Temperature calculation in steel and composite beams

Proposal 1 - Item 4.2.5 of EN 1993-1-2

Proposal 2 - Item 4.3.4.2.2 (11) of EN 1994-1-2

prof. Lesław Kwaśniewski, Piotr Smardz

EN 1993-1-2

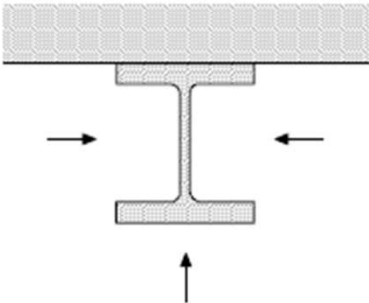
- ▶ For structural steel elements the calculation of temperature increase in an unprotected member exposed to fire is based on the assumption of uniform temperature field in the element. The formula for temperature increase is therefore based on a single section factor of the structural member (4.2.5 of EN 1993-1-2).
- ▶ For certain elements (e.g. large beams with tall webs supporting concrete floors) this assumption does not seem to be realistic.
- ▶ This approach is also not consistent with calculation methods for composite floor presented in EN 1994-1-2
- ▶ For beams / columns with 4-side exposure the assumption of uniform temperature seems to be realistic

- ▶ Provide criteria when it is appropriate to assume uniform temperature distribution in a steel beam, and when it is more appropriate to split the member notionally into different parts, each having uniform temperature – in the same way it is done for composite beams

Proposal 2 - Item 4.3.4.2.2 (10) of EN 1994-1-2

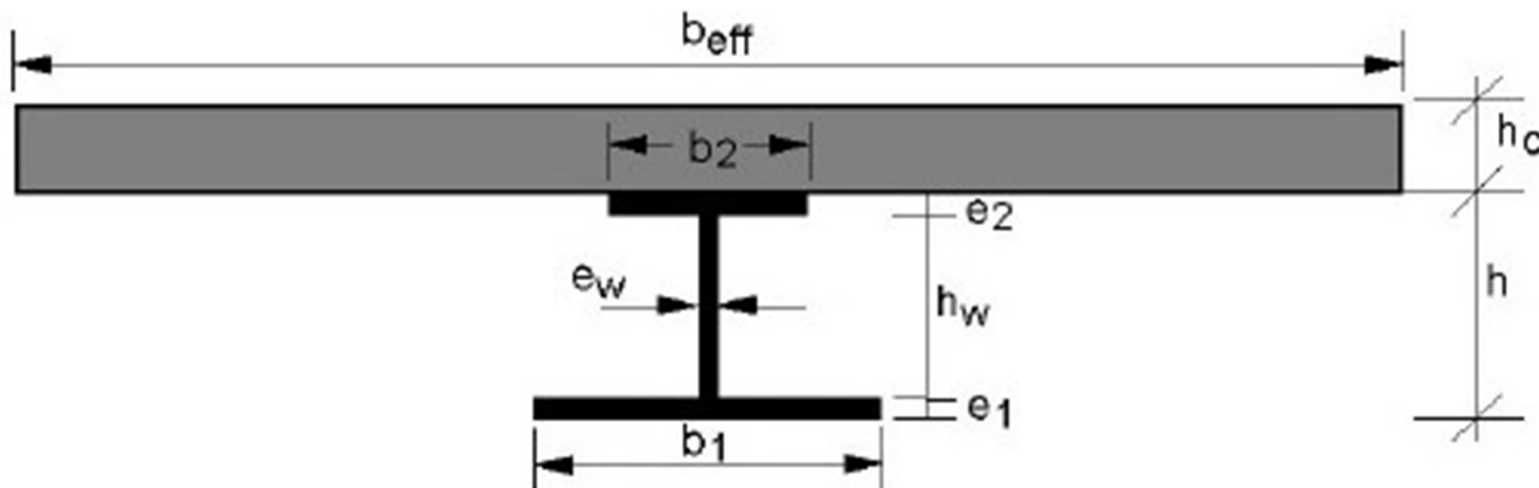
„If the beam depth h does not exceed 500 mm, the temperature of the web may be taken as equal to that of the lower flange”

No limit is set for the ratio of section factors for the web / flange or the minimum thickness of the flange.

- ▶ Provide additional criteria for the limiting ratio of the web thickness to lower flange thickness (or section factor) beyond which the temperature of the web needs to be calculated and not taken as equal to that of the bottom flange
